IVR V1 Open Pit

IVR West Open Pits

IVR West Open Pits

Observations - Southeast Wall

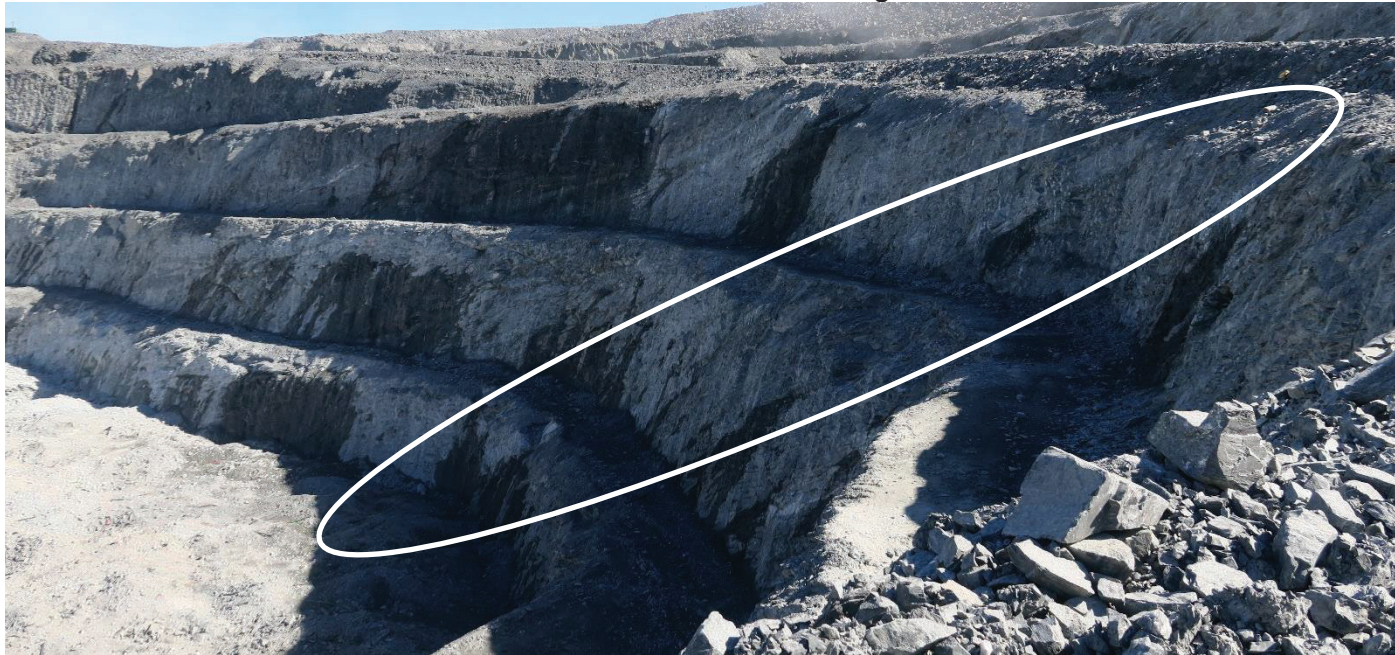
- Final wall in Design Sector V0C.
- The wall is performing well. Half barrels are visible and very little material is present on the catch benches.
- Several persistent cross-cutting features were identified during the 2021 inspection (examples circled below). These structures were not prominent in the structural data underlying the design of the open pit and there was a concern that they could impact the achievable slope geometry. It now appears that these structures were localized as they have not influenced the bench performance at depth.

Observations - North Wall “Turtlehead”

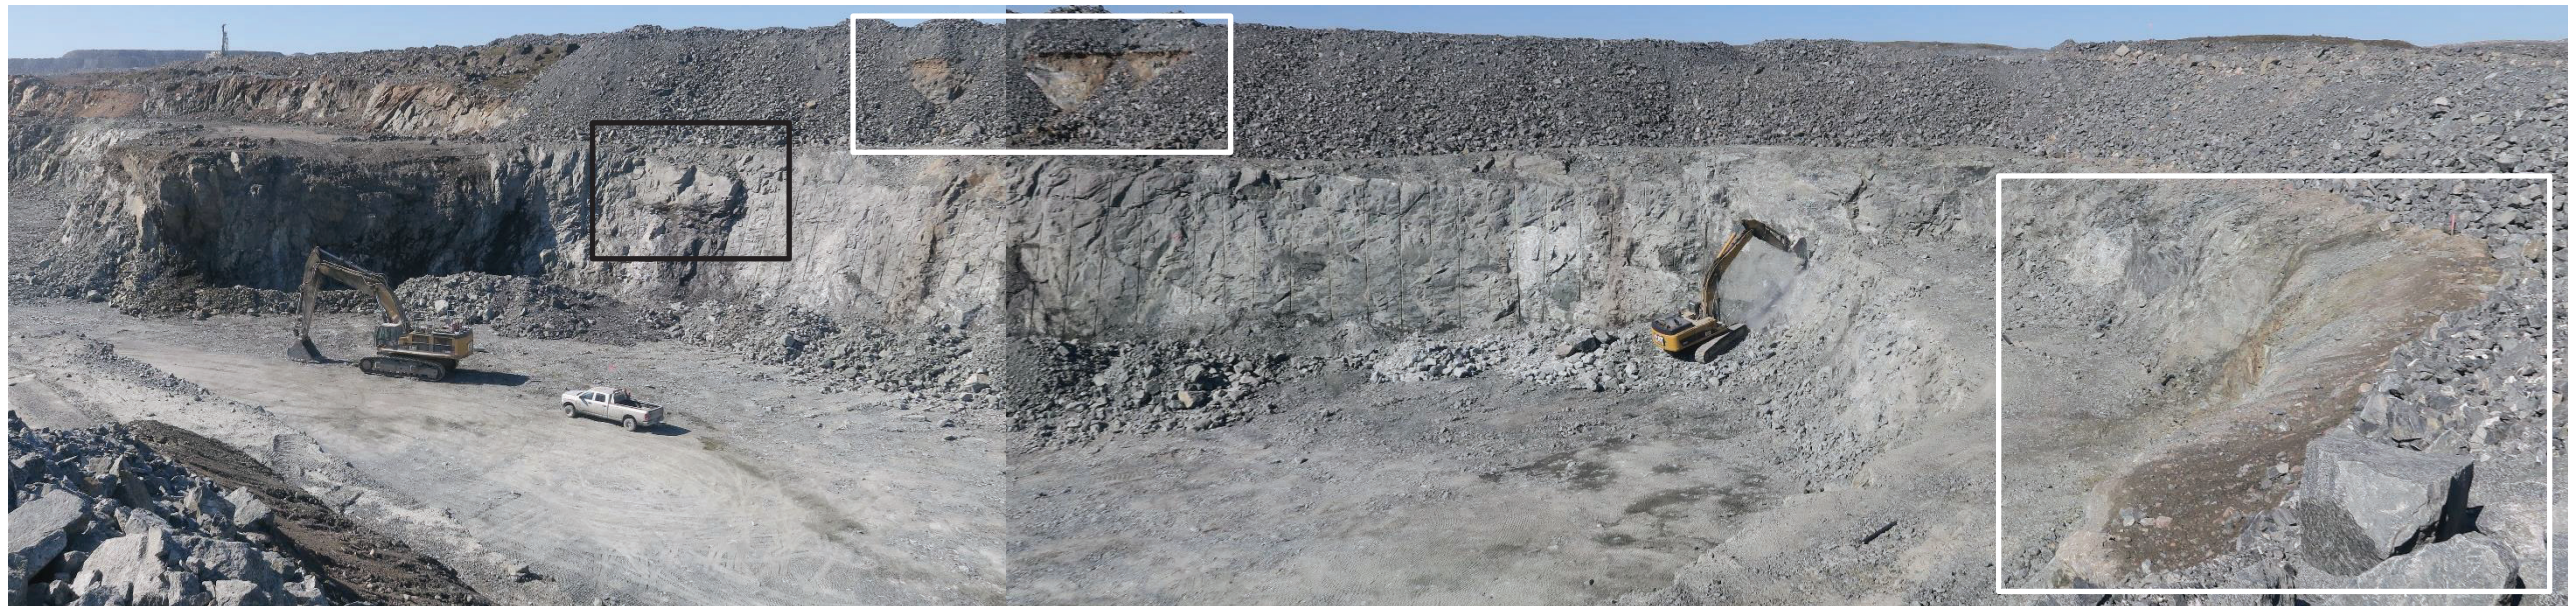
- The overburden in this area was thicker than expected, resulting in a large thermal cap. There are gaps in the thermal cap (outlined below in white) and exposed overburden is present along the crest of the upper bench. The overburden is likely to ravel over time. Section 1.135 of the Nunavut Mine Health and Safety Act requires unconsolidated material to be excavated back a minimum of 2 m from the crest. The thermal cap should be remediated in this area.

- Scaling of the end wall was in progress at the time of the inspection. Frequent hard toes were noted by the operator. The foliation is perpendicular to the wall in that area and significant scaling was required due to the presence of numerous small wedges/blocks. A potentially unstable block was observed on the wall (outlined below in black).

- A portion of the safety berm was missing at the end of the crest road where the photos below were taken. The berm should be re-established.

Hazard / Risk Assessment

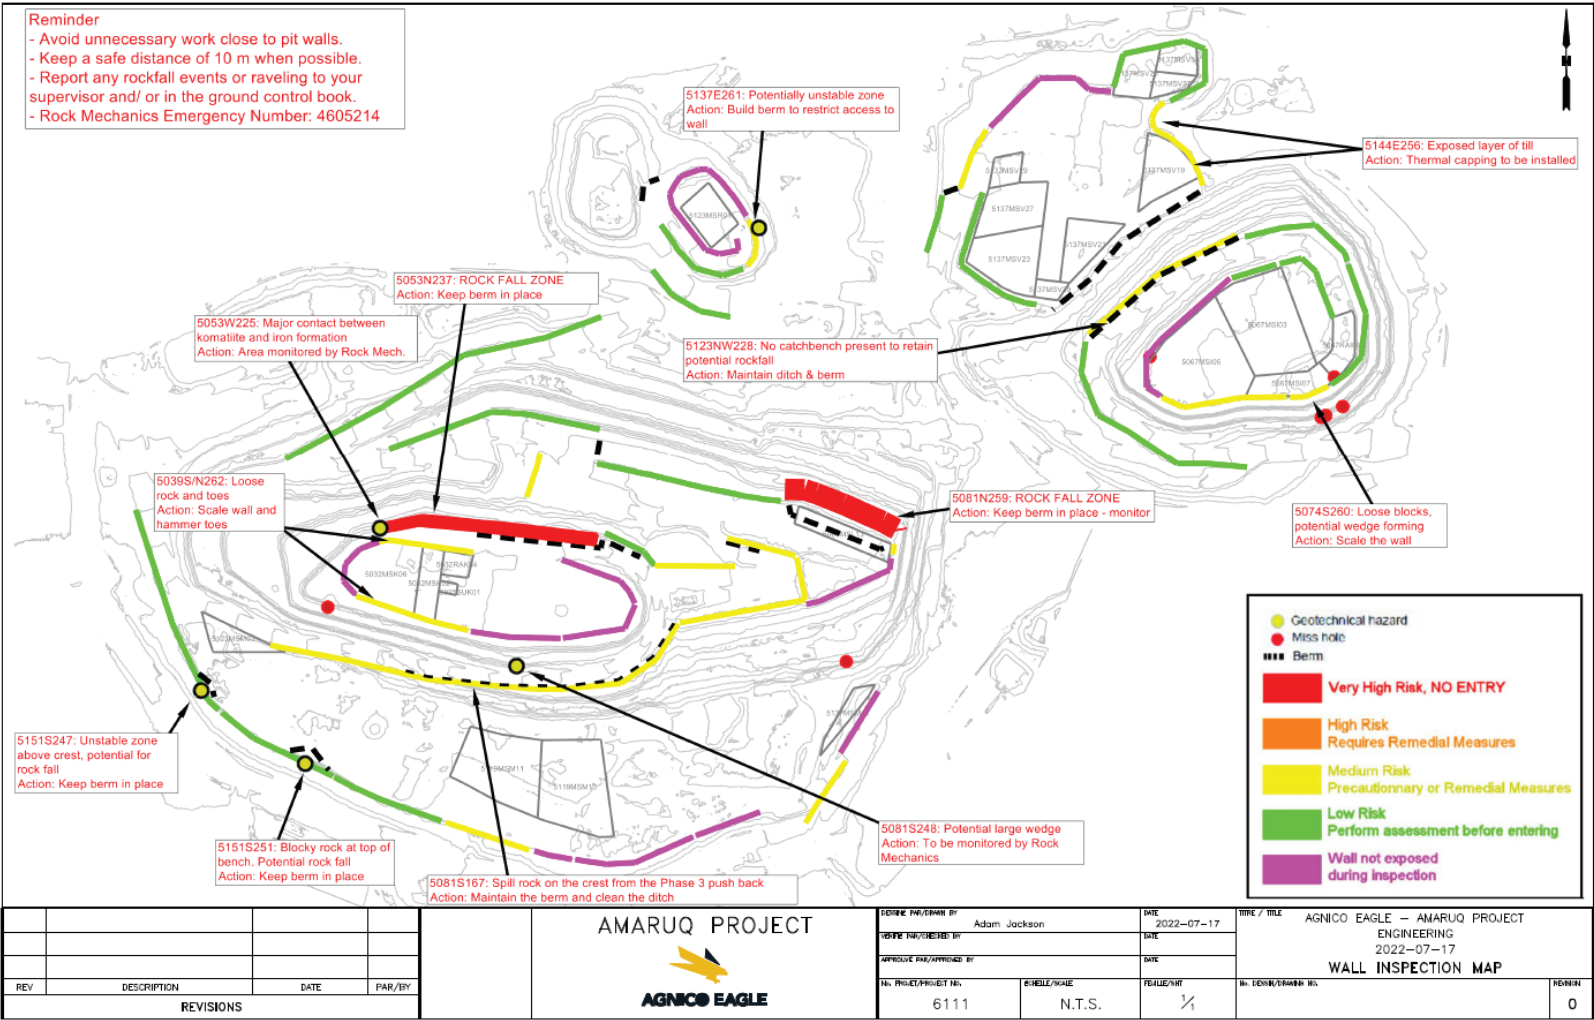
- Identified hazards and the required mitigation work are tracked on a Hazard Map available to the workforce. The map is an effective tool.
- There continues to be limited guidance on how to select the risk ratings. Recommend providing detailed guidance, including examples, on how to determine these ratings. The goal is to ensure that each member of the Rock Mechanics team can perform the assessment in a consistent and reliable manner.
- The map is updated every two weeks. However, with multiple pits in progress it is often rapidly out of date. Recommend issuing an update weekly (or more frequently) if there are notable changes. One possibility would be to issue a brief supplement that focuses solely on what has changed.

SSR Monitoring - Alarms

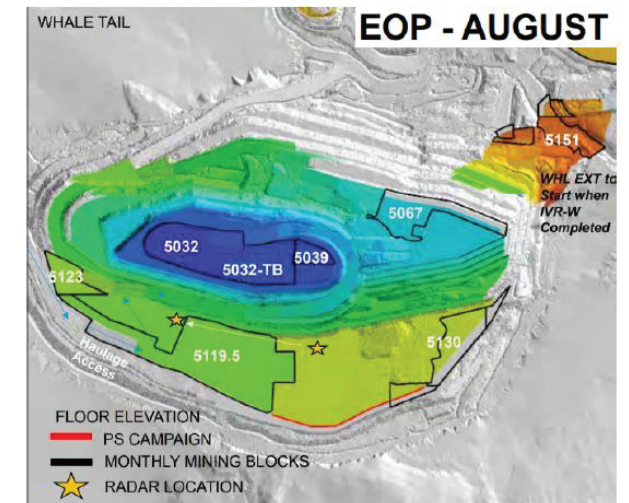
- Red alarms are not used. The Orange alarms are adjusted on an informal basis in response to observed conditions. For example, a lower deformation threshold may be used for an area of concern at a low angle of incidence. Additional parameters (e.g., coherence, inverse velocity) are used to interpret the observed movement on a case-by-case basis but are not incorporated into the alarms.

- The strategy of using Orange alarms and adjusting the alarm parameters on a case-by-case basis relies on an experienced operator who is familiar with the historical slope performance and is comfortable interpreting the data. The mine has recently developed a procedure for using the radar, including the process of setting alarms. This is a useful reference and particularly important given the number of new staff joining the Rock Mechanics team. However, neither the procedure nor the GCMP explain why the alarms have been set at their current values or provide guidance on how they can be adjusted based on different circumstances. While it is recognized that it is not practical to cover all eventualities, recommend providing additional guidance on how to define alarm criteria.

- As the open pit gets deeper and the potential for multi-bench failures increases, Red alarms will need to be developed for some areas in order to manage the associated risk. Recommend developing a Red trigger condition as a backstop for unexpected or unprecedented conditions.

SSR Monitoring - Coverage

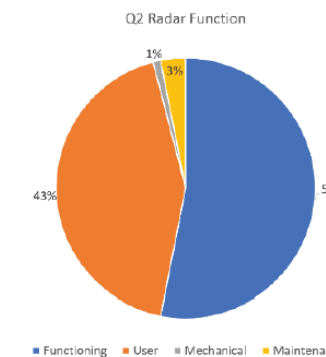
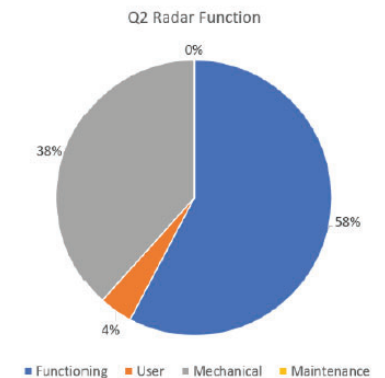
- Radar SSR253 was damaged by flyrock and was only operating 18% of the time in Q1. The radar was repaired in April and availability improved in Q2 to 53% (a large proportion of the remaining downtime was due to intensive mining in Phase 3, represented by the orange “User” category in the chart).

- Radar SSR560 was operating 100% of the time in Q1, reducing to 60% of Q2 due to an internal computer failure.
- It is understood that GroundProbe’s technical support has improved and this has helped with radar availability.

- As the radar is the sole quantitative monitoring system for the open pit slopes, this amount of downtime has a significant impact on the mine’s ability to manage geotechnical risk. This reinforces the need for additional monitoring systems.
